University of the Philippines OPEN UNIVERSITY

SUPPLEMENTAL BID BULLETIN NO. 24-008

This Supplemental Bid Bulletin No. 24-008 is to amend or modify items in the Bid Documents and in response to the queries raised during the pre-bid conference conducted on 04 April 2024 for “Completion of the Convention Hall of the International Convention Center” to wit:

A GROUND FLOOR ADDITIONAL POWER LAYOUT
 E 2 SCALE 1:150M

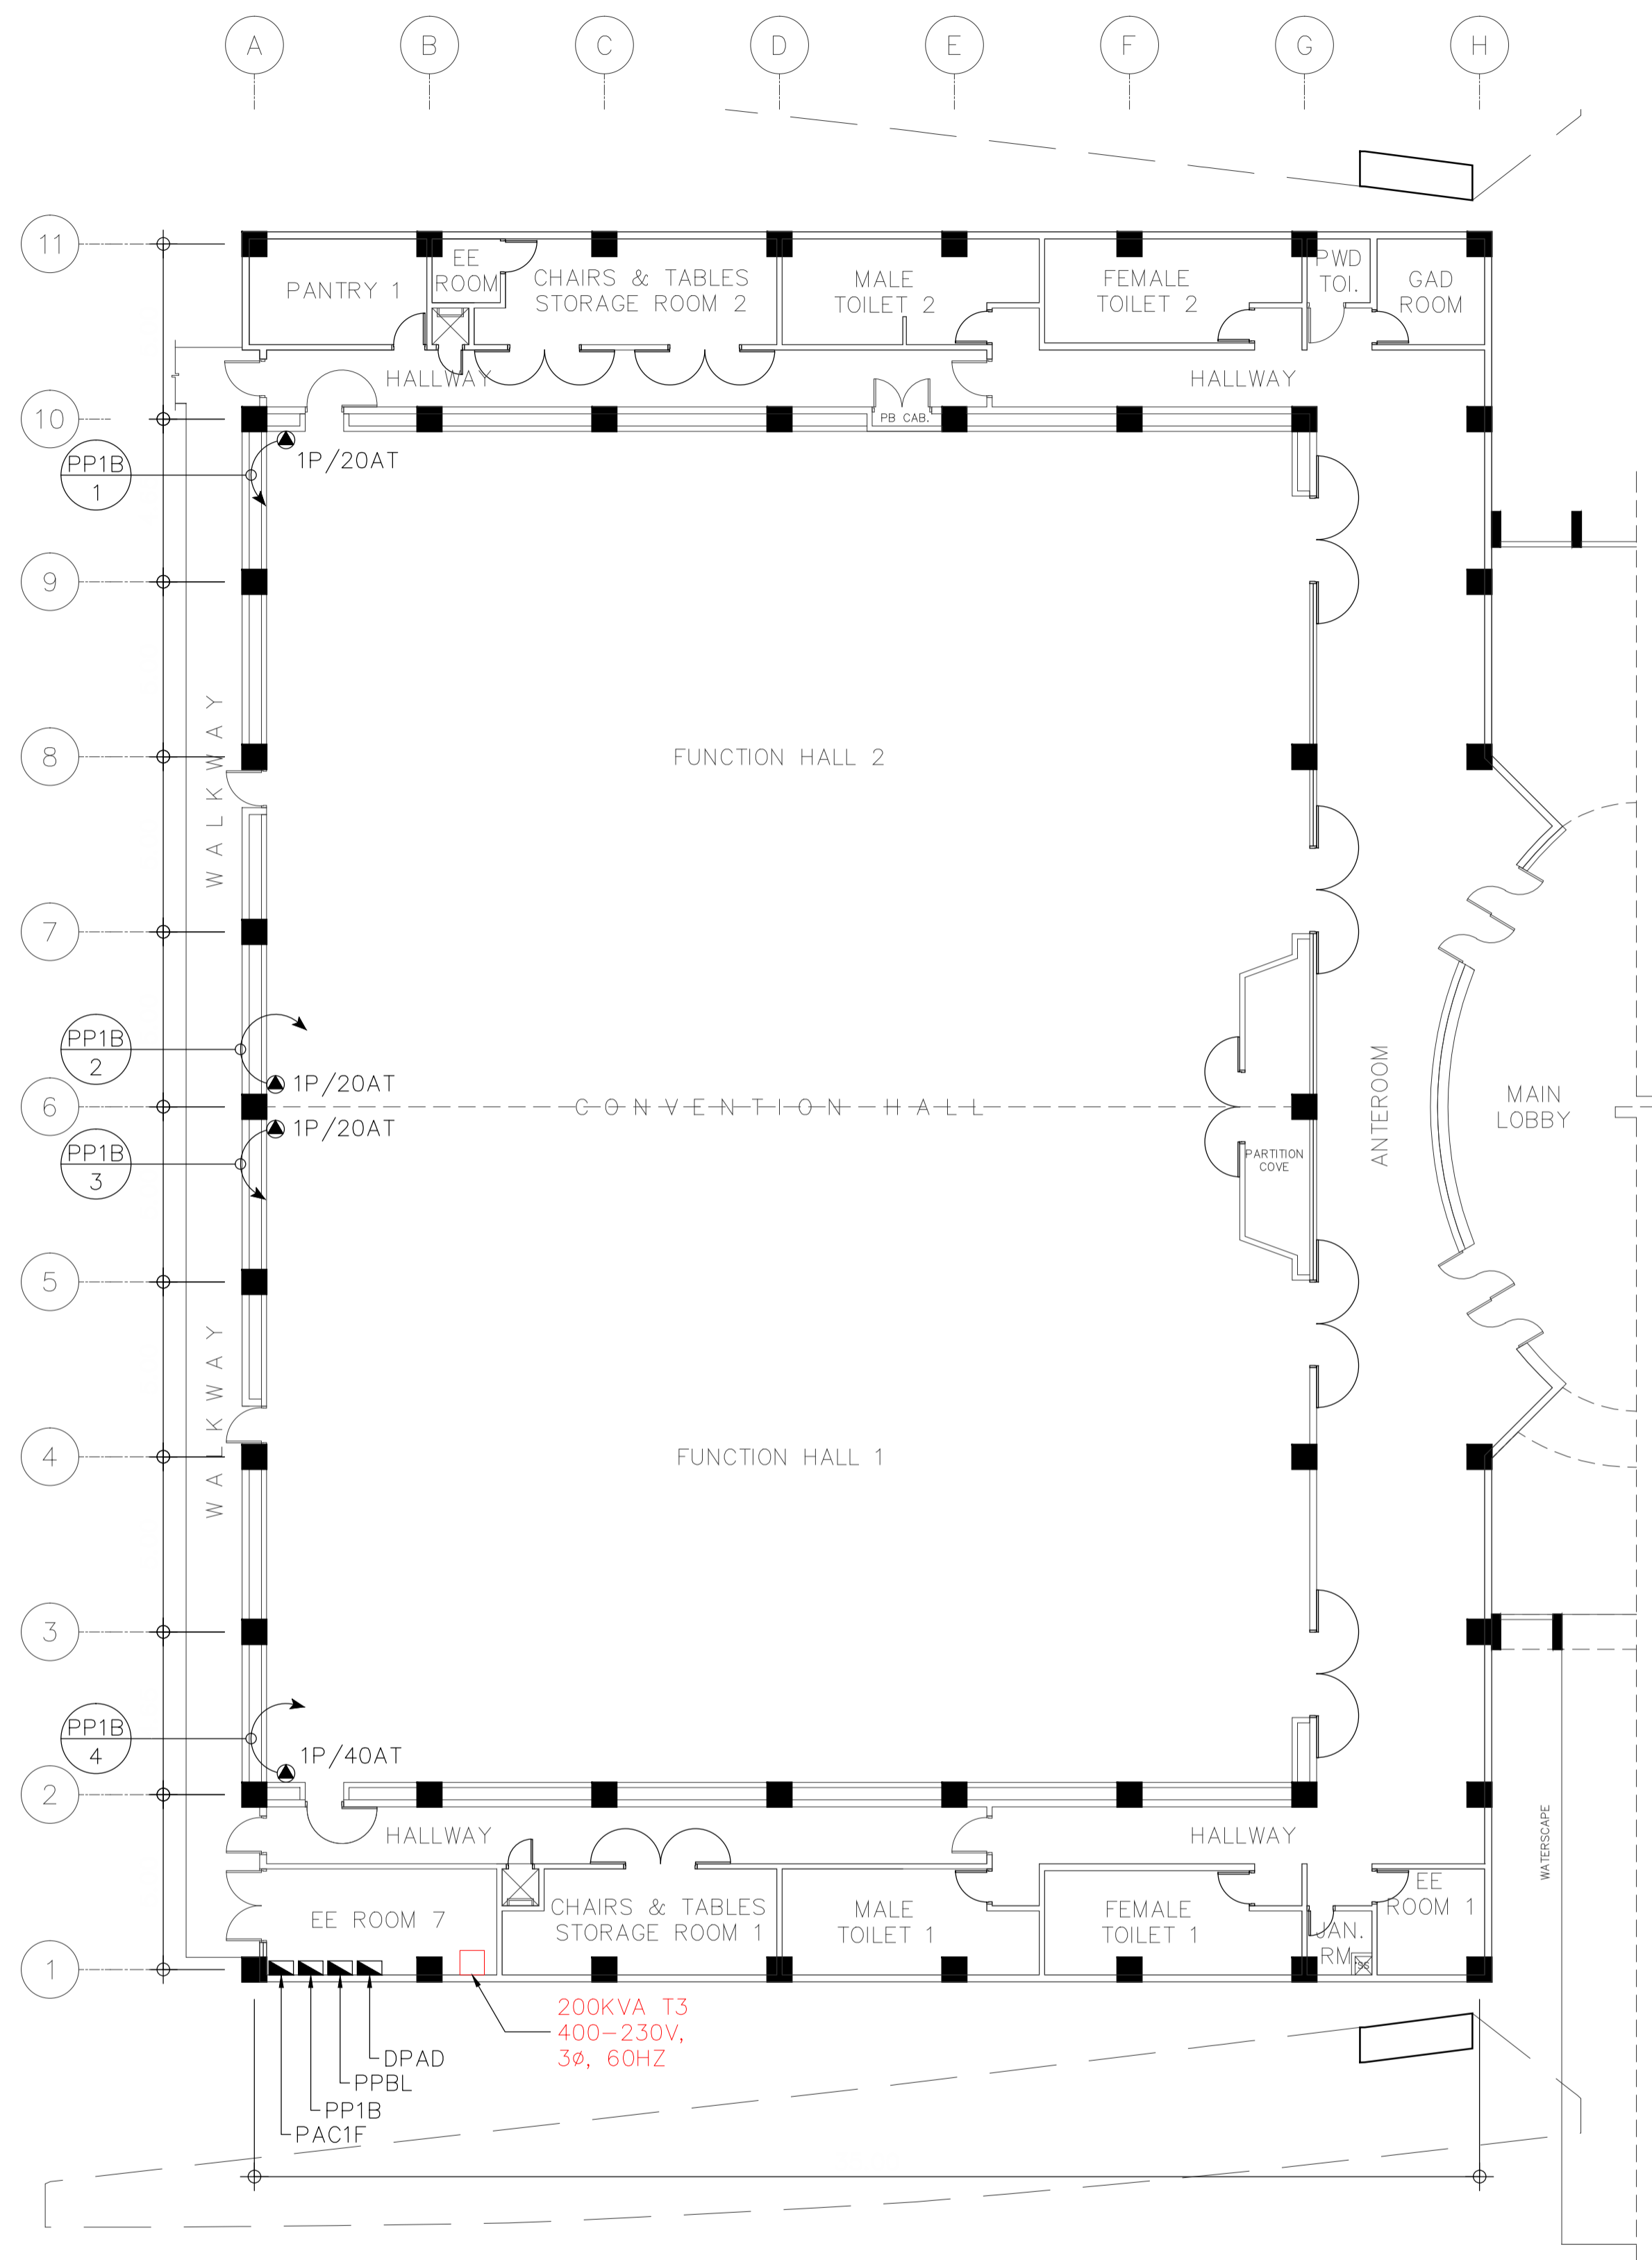
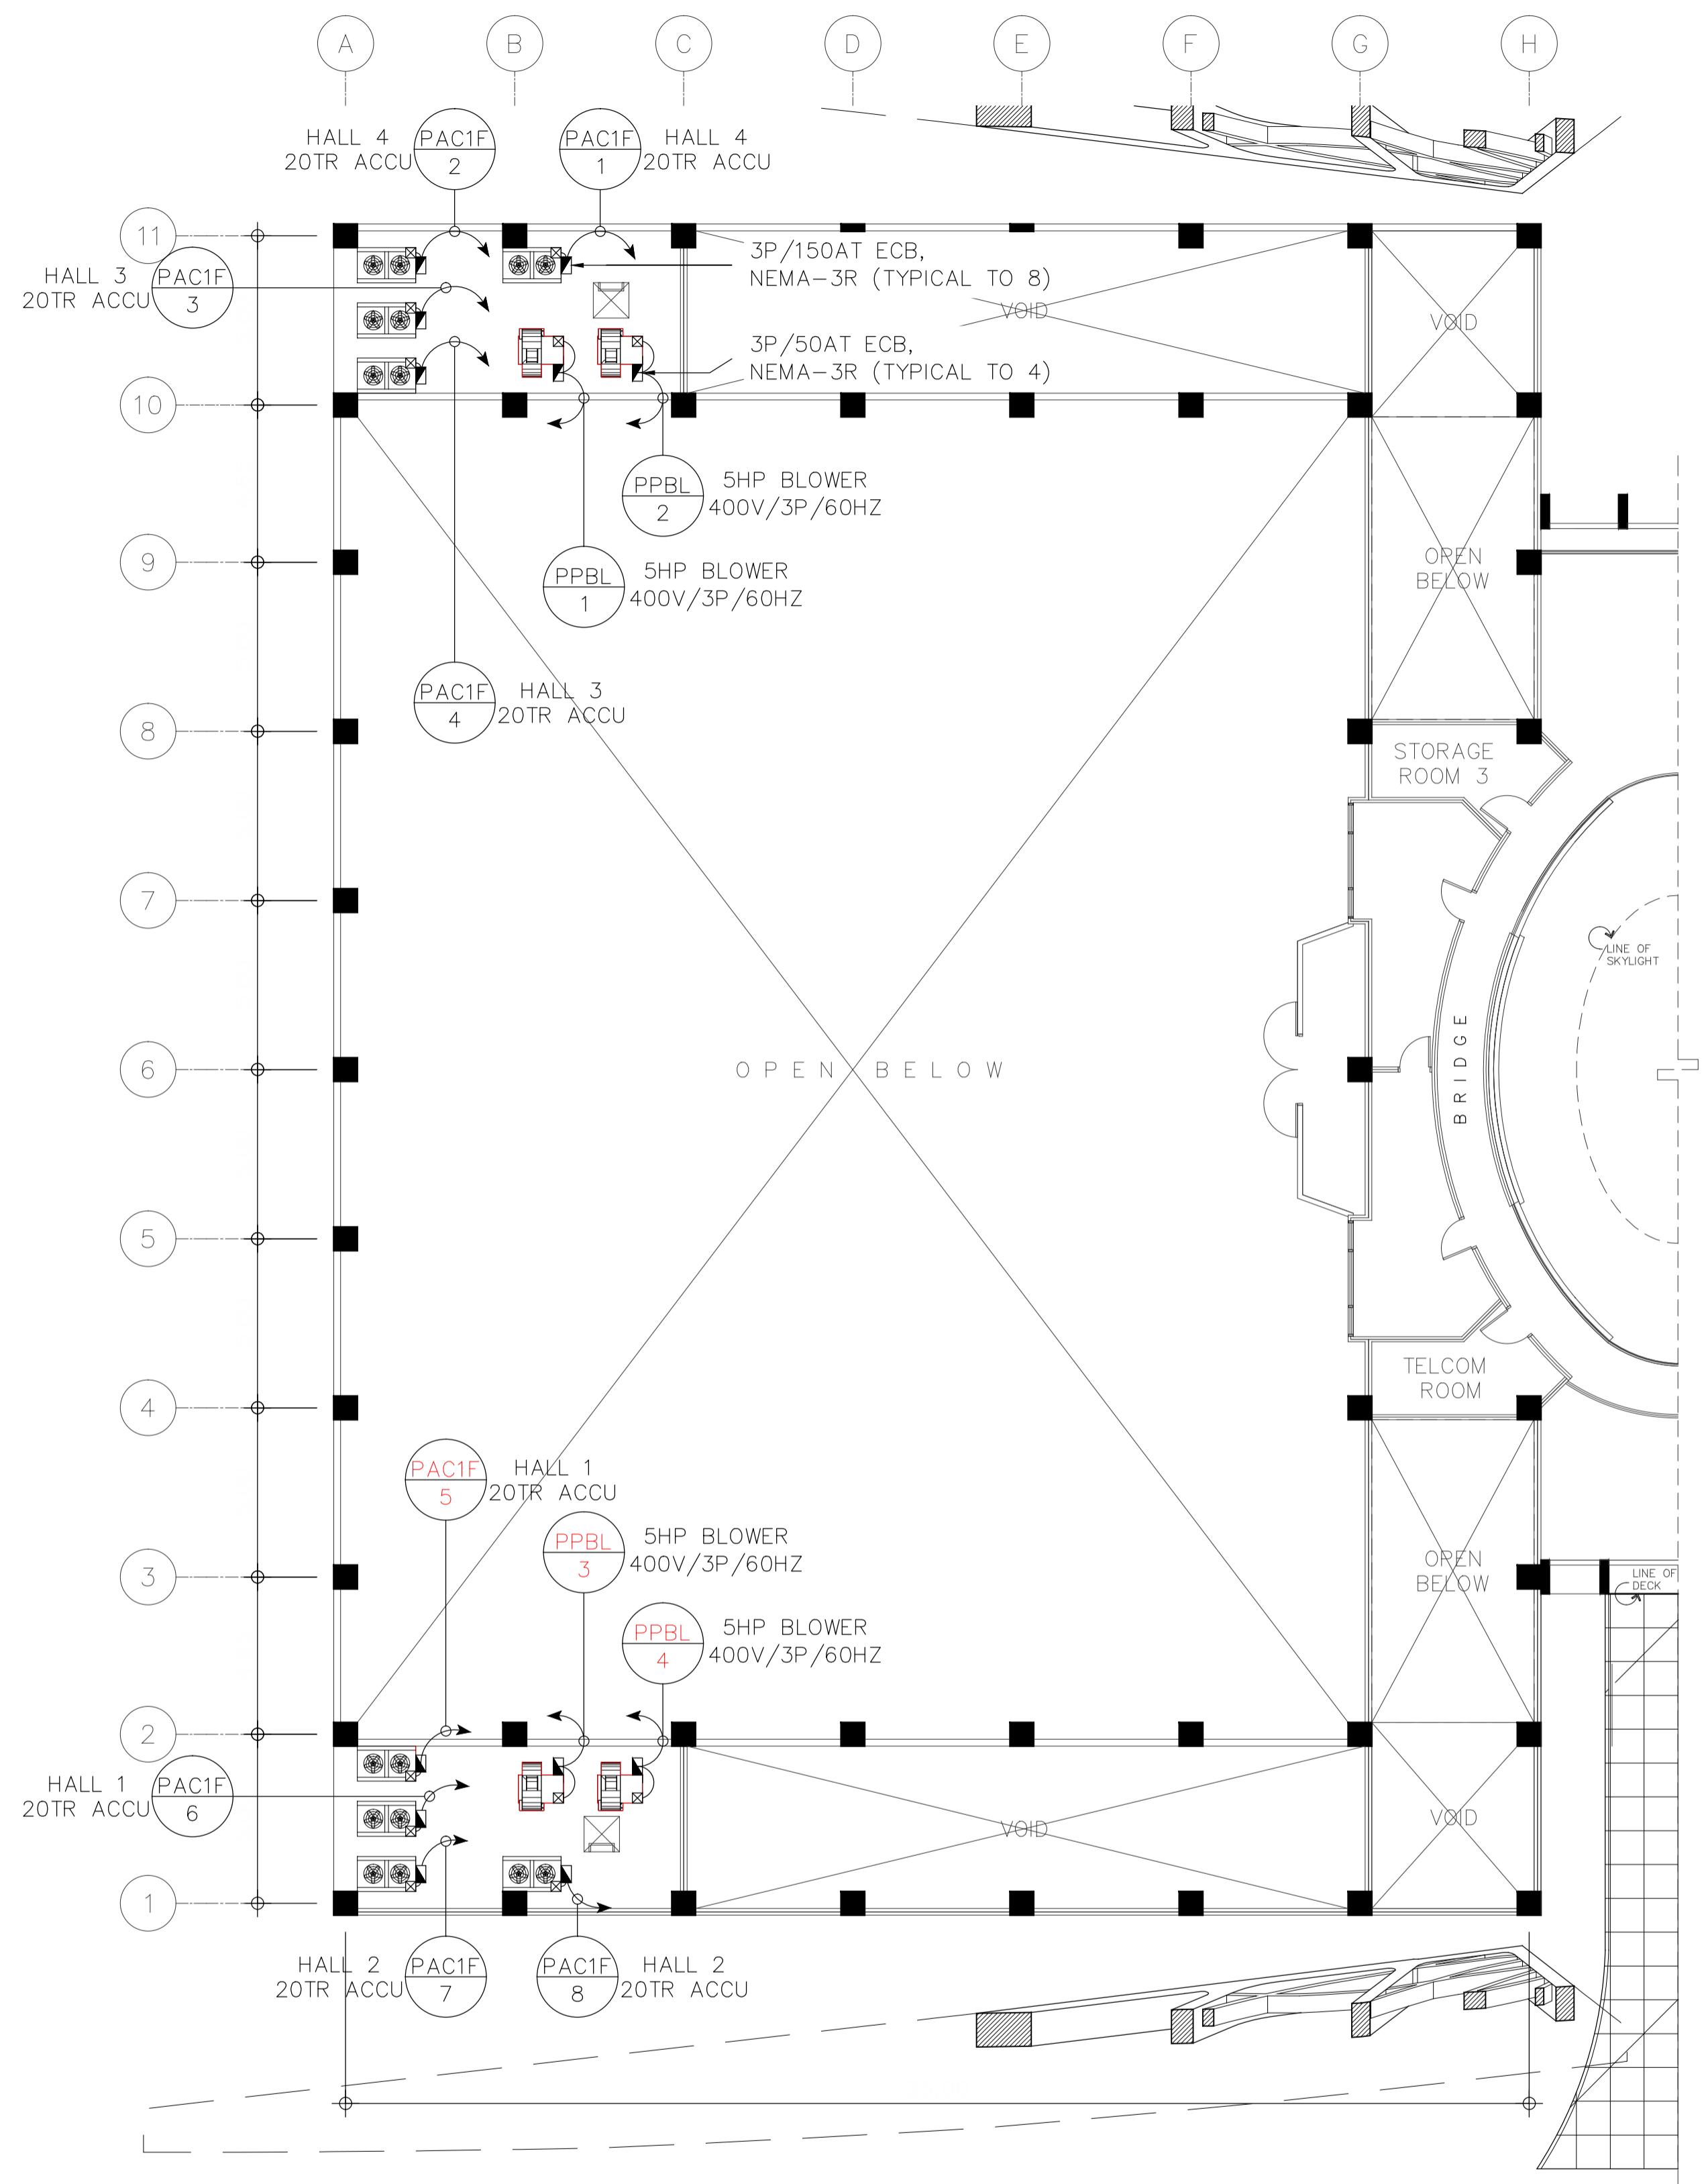
3. Plans, drawing details of the following items of works: F. Electrical Works 1. a. LVSG, 400V, ATS type NEMA 1 free standing b. Panel “PMC” c. Panel “FPP” 2. 200kVA, 400V, 3P-230V, 3P, step down, dry type Transformer NEMA 1, 60 Hz	Refer to the attached single-line diagram for reference. Refer to the power layout (E-2) for reference.

6. Kind of finish to be used on the toilet partitions, solid color or wood.	Refer to Section 10 21 00 of the Technical Specifications for reference. Subject for Architect's approval. Submit product brochures, documents and swatches for approval during construction.
7. Construction of temporary barracks for the manpower within the site	Submit temporary facility layout for approval.
8. Overtime works	Overtime works are allowed.
9. Construction of a temporary fence and scope of fencing	Only the front area will be the scope of the temporary fence
10. Electrical plans	Refer to E-2, load schedule and single-line diagram for reference.
